From: Neil Duffield
Sent: 23 March 2021 14:50
To:
Cc: planning@northyorkmoors.org.uk
Subject: NYM/2021/0063/FL Flushing Meadows Egton E12014-08 Client rev dwgs

CLIENT: Mr S & Mrs L Shaw		
PROJECT: Flushing Meadows Egton YO21 1UA		
A3	DRN: C Eynon	DATE: 01/02/21
SCALE: As shown	ISSUE: Preliminary

CLIENT: Mr S & Mrs L Shaw
PROJECT: Alterations to Flushing Meadows Egton YO21 1UA

DRAWING No: D12014-02 REV: D

DRAWING TITLE: Location Plan and Block Plan	
DRAWING NR: D12014-01	REV: B

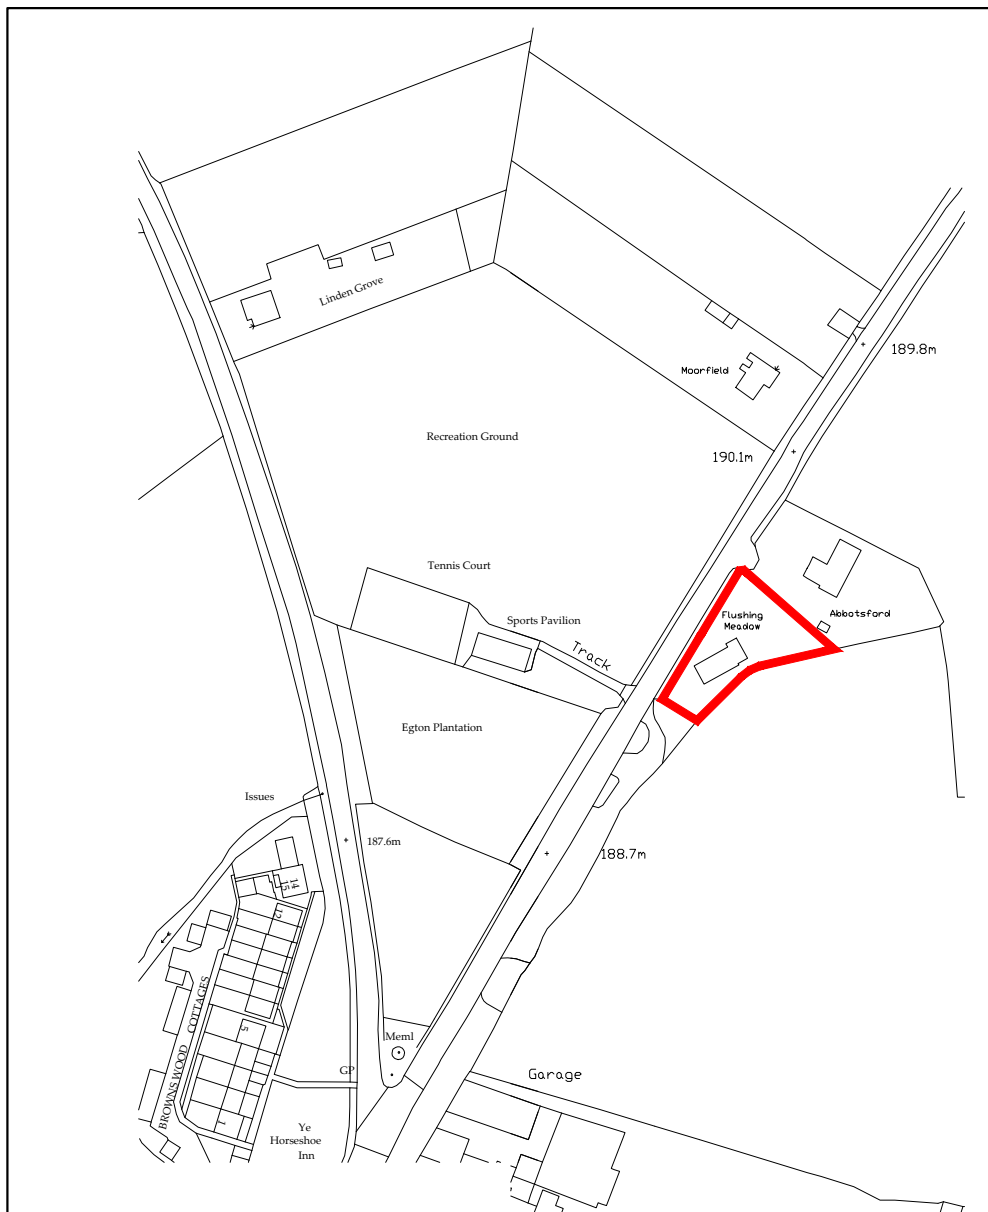
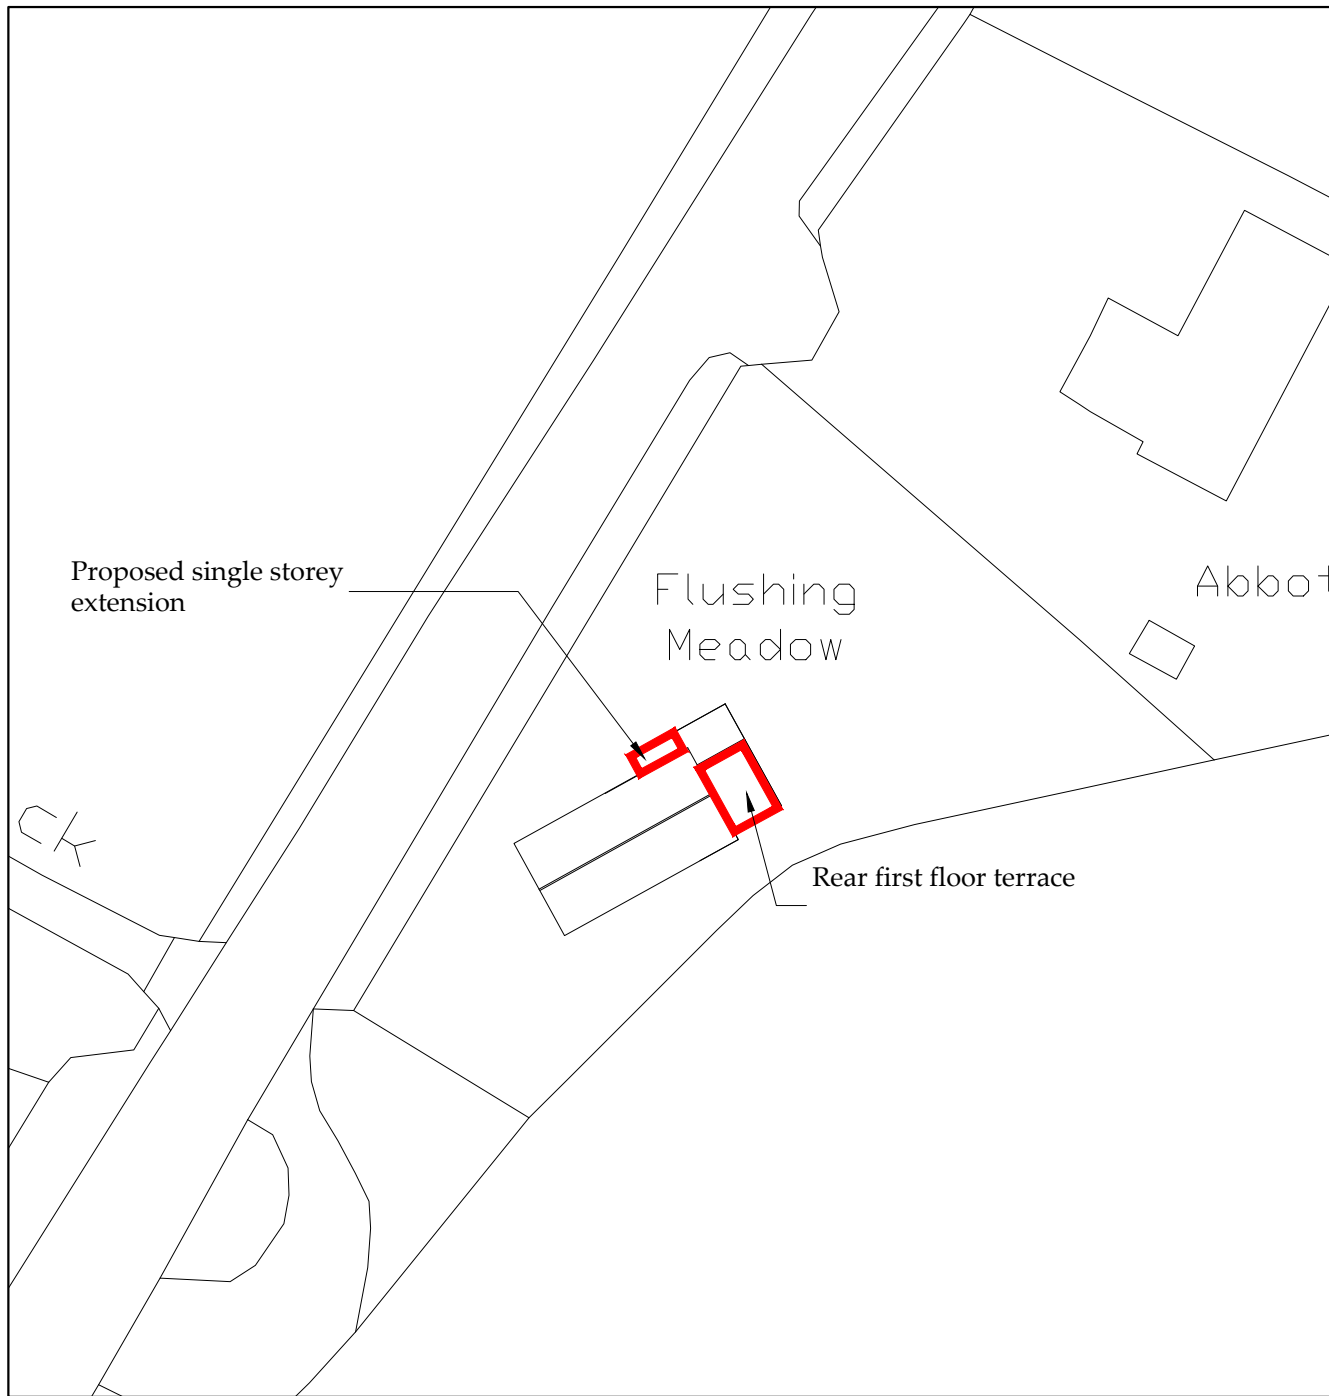
REV	DATE	BY	AMENDMENT	CHKD	APVD
B	23/03/21	CE	Red line amended		
A	01/02/21	CE	Issued for approval

Drawing: Existing and Proposed Plans and Elevations

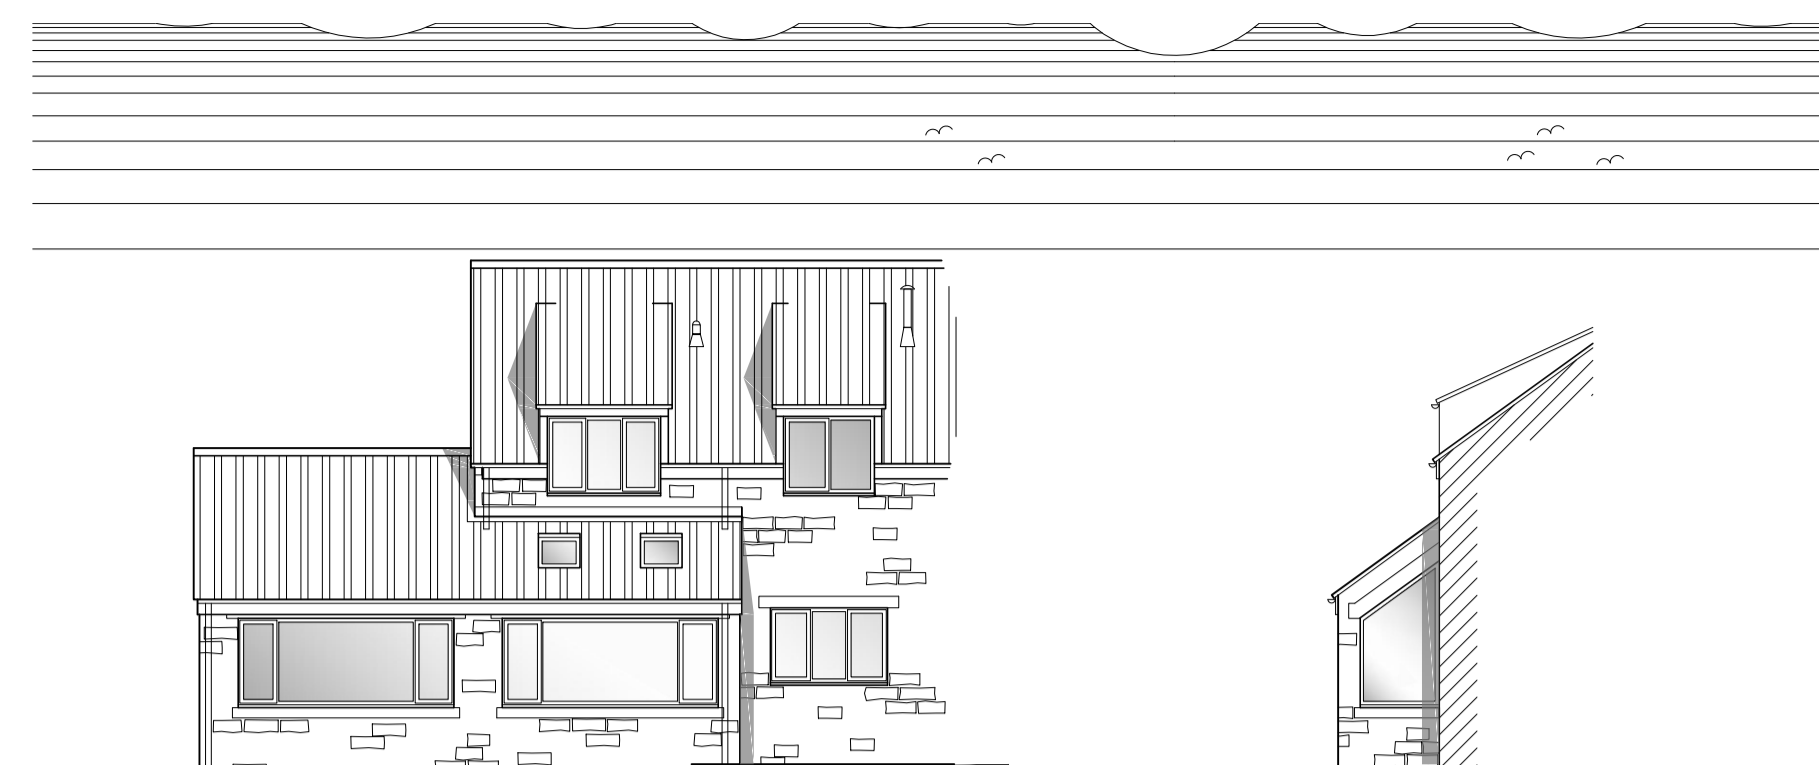
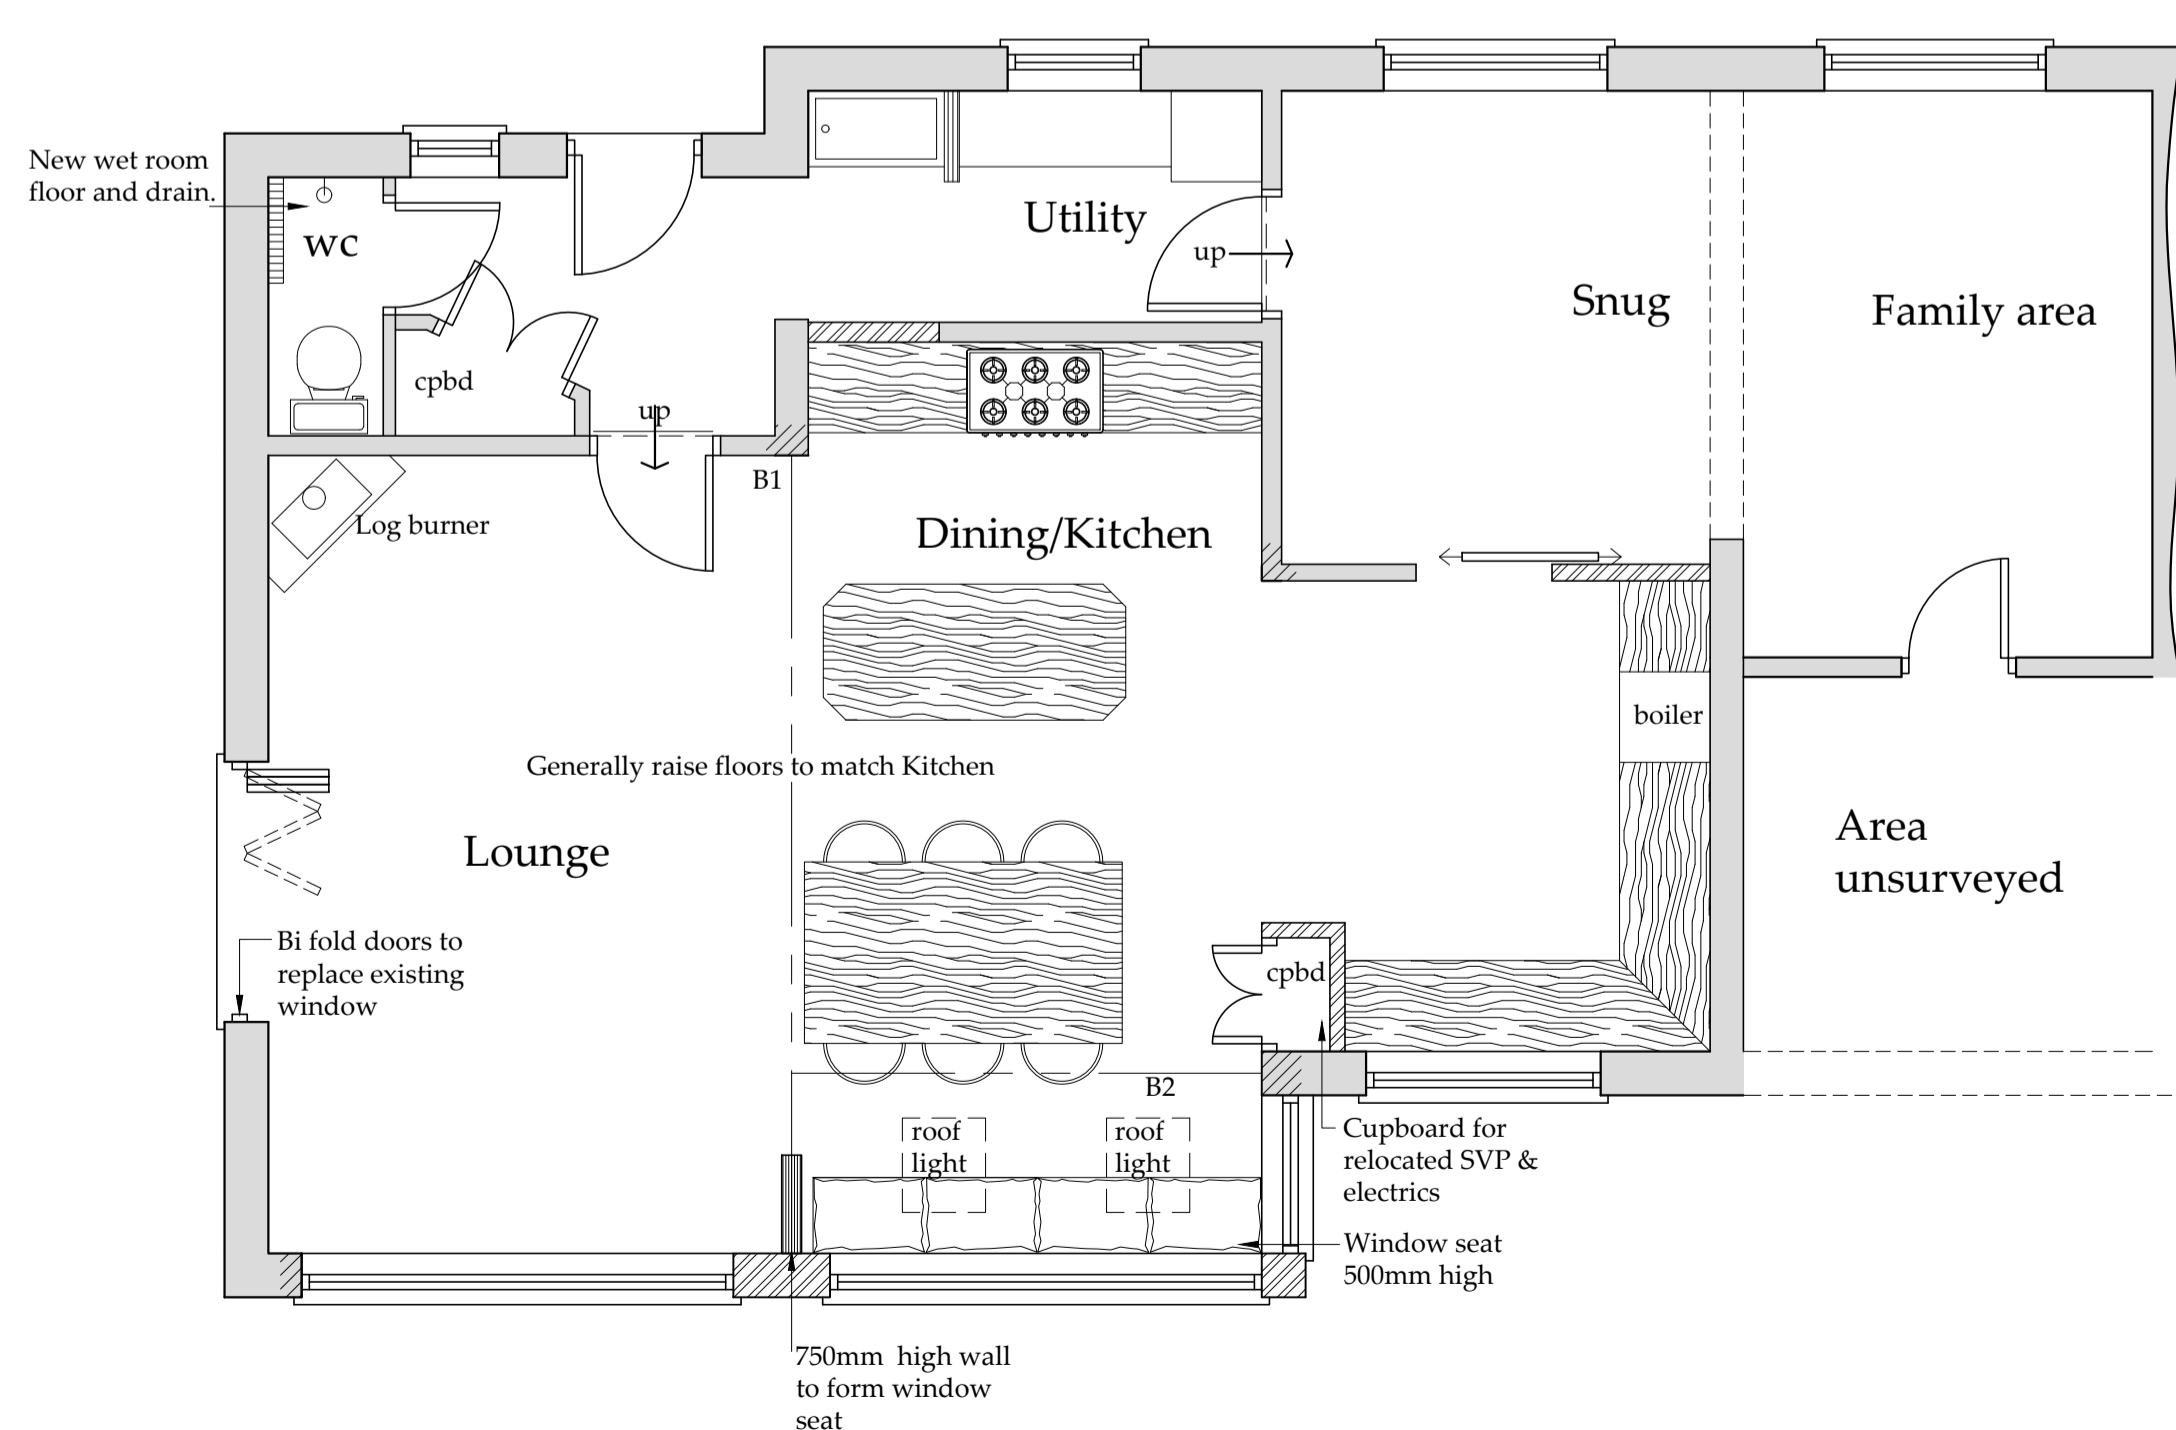
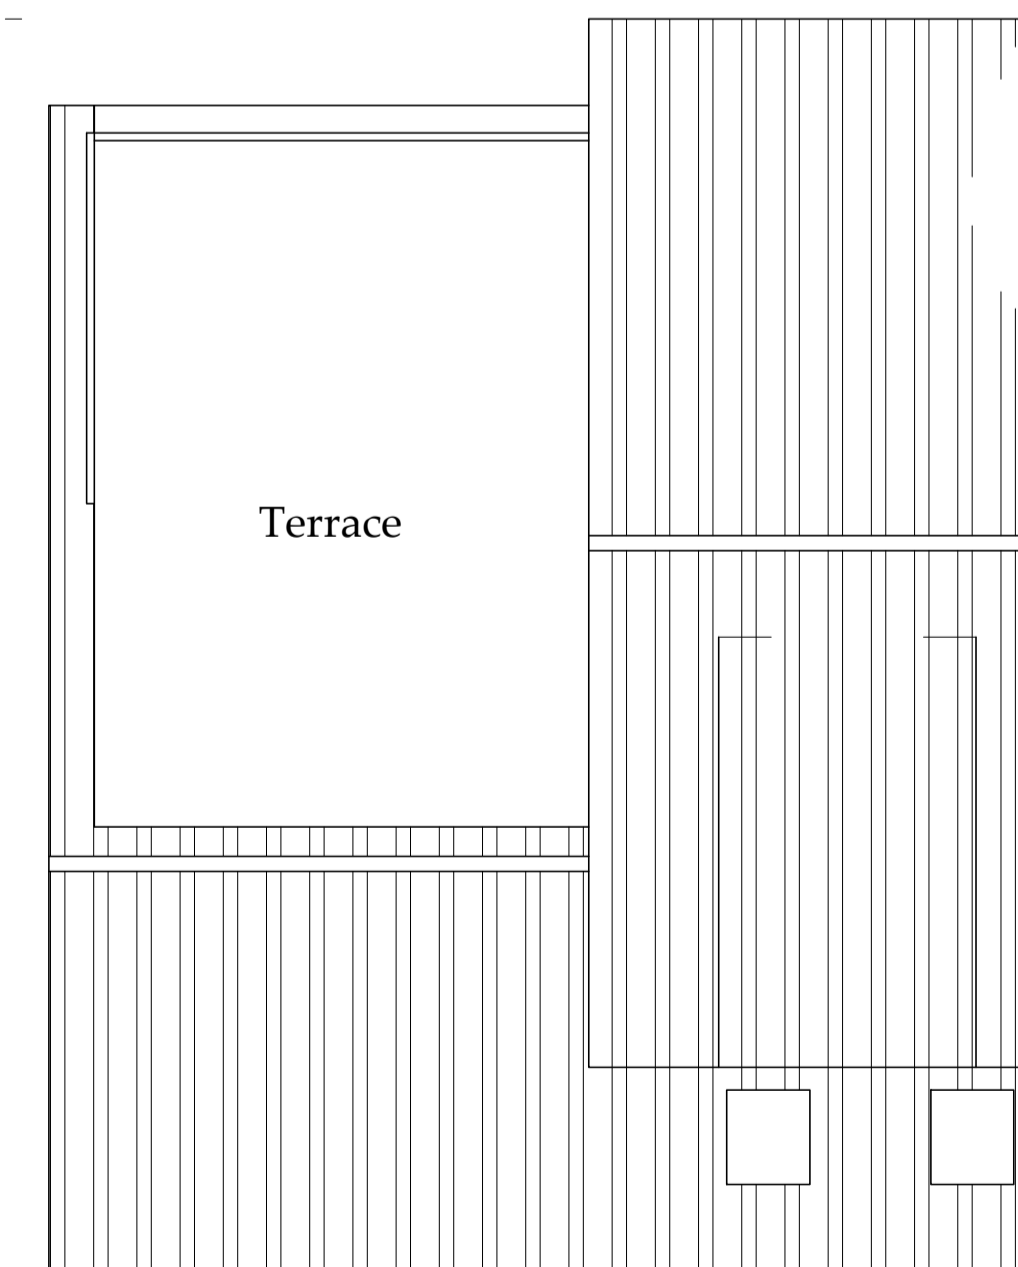
Please see attached the drawings for the above application amended to remove the external stair access. I hope these are as required and the approval can be granted. Any queries please let me know.

D	23/03/21	CE	Stair removed
C	28/01/21	CE	Roof plan added
B	20/01/21	nid	Client details and rear elevation
A	06/01/21	CE	Issued for approval

Replace existing window with door
Terrace 'cut out' of existing roof
Line of terrace, tapered glazed balustrade
